Kitsap County Department of Community Development

Staff Report Administrative Revision

Project Name: Kingston High School Parking
Expansion

Type of Application: Minor Revision to
Conditional Use Permit (CUP)

Attach B - Critical Areas Map

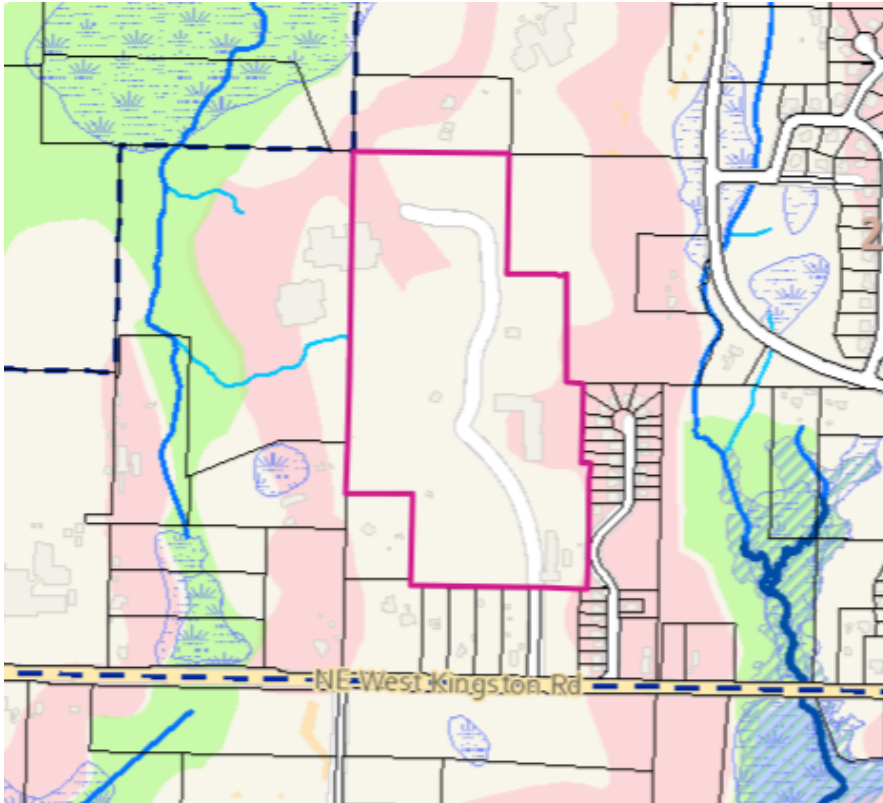
Construction of a parking lot for 28 additional spaces requires mitigation sequencing beginning with buffer averaging. The project would reduce area at the southeast and increase buffer in the north portion of Wetland A. According to KCC 19.200.220(C)(2). The proposal to decrease the southern portion of Wetland A buffer by 2,565 square feet and increase the northern portion of Wetland A buffer by 2,807 square feet results in a 242 square foot net gain through buffer averaging and an increase to a high functioning buffer area onsite while reducing the low-functioning buffer and meeting no net loss standards.

Staff Comment: Buffer width averaging is supported by staff to meet requirements as described in Chapter 19.700 (Special Reports), including demonstration of mitigation sequencing as described in Section 19.100.155(D) shown in report from Soundview Consulting and Trinity. The new parking lot is proposed in an area developed with mowed grass, an existing building, and compacted gravel driveway. The section of buffer located within the proposed parking lot footprint is currently degraded due to the presence of non-native maintained lawn, and as such provides minimal buffer functions to Wetland A. The proposed buffer increase is proposed north of Wetland A within an area vegetated with native conifer forest.

The minimum buffer width at any point will not be less than seventy-five percent of the standard buffer width, except Category III and IV wetlands with a habitat score of five points or less may be no less than fifty percent of the standard buffer width at any point. The current standard buffer is 150 feet in width and will decrease to 112.5 feet in width, which is 75 percent of the standard buffer width.

18. A split rail fence with buffer signage shall be installed and/or maintained along the perimeter of the minimum 75-foot stream buffer. There is an added condition of approval at the end of this report that buffer signs are required to be placed at 50-foot intervals and attached to the rail fence. Buffer signs are available from the Department of Community Development.
